Airport Moving Map Alert

Subject: Turkmenbashi, Turkmenistan
Turkmenbashi (UTAK)
Cycle 2604

***Airport layout changed.
RWY 16L/34 status incorrect.***

UTAK_2604

JEPPESSEN TURKMENBASHI, TURKMENISTAN
10 APR 26 10-9 Eff. 16 Apr
TURKMENBASHI

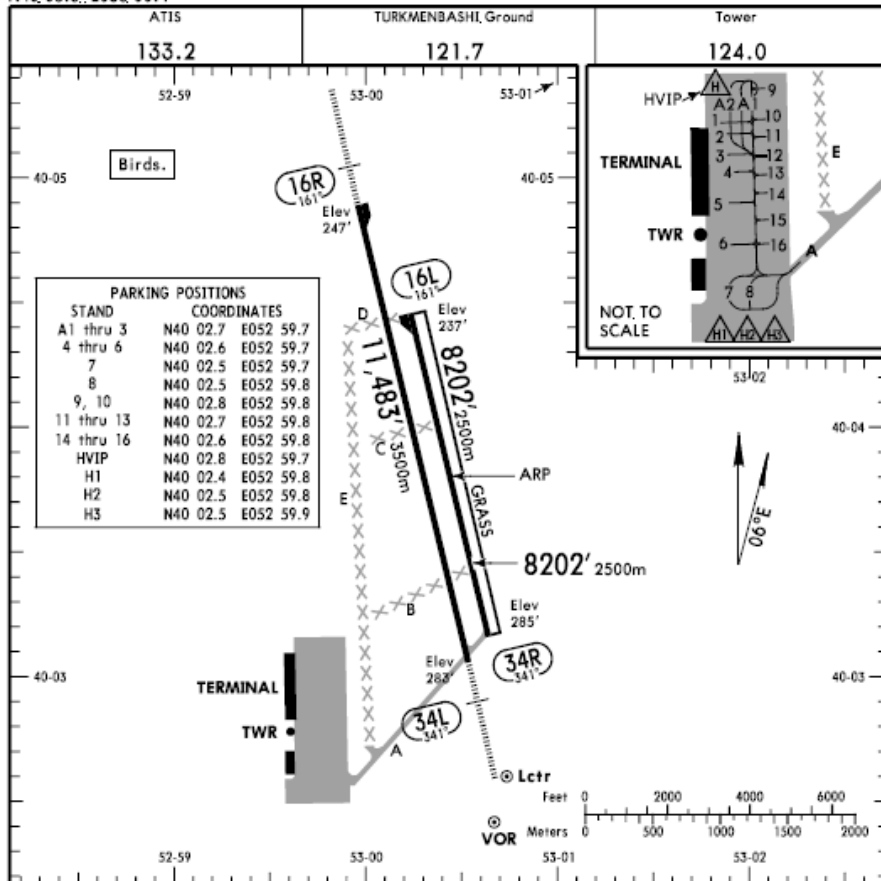
The following changes are not reflected in cycle 2604 data:

- Parking Stands A1, A2 are added
- Parking Stands 9-12, 14-16 are added
- Parking Stand 13 is relocated next to new Parking Stand 12
- FATOs H1, H3, HVIP are added
- FATO H2 is relocated next to new FATO H1
- TWY F is removed
- RWY 16L/34R lighting systems are updated
- Control Tower, Terminal and Cargo building labels are added

Additionally, NOTAM O0035/26 ending on 23:59 [UTC] 16 April 2026, was not reverted, therefore the following change is not reflected in cycle 2604 data:

- RWY 16L/34R is open

Revised data will appear in Jeppesen Airport Moving Map and A816 formatted data for cycle 2605, effective 14 May 2026. Until then this Alert will be posted on the Jeppesen Web site: [Notices and Alerts](#). Please refer to the local NOTAMs and Turkmenbashi, Turkmenistan (UTAK) 10-9 chart dated 10 APR 26, effective 16 APR 26 for valid information.
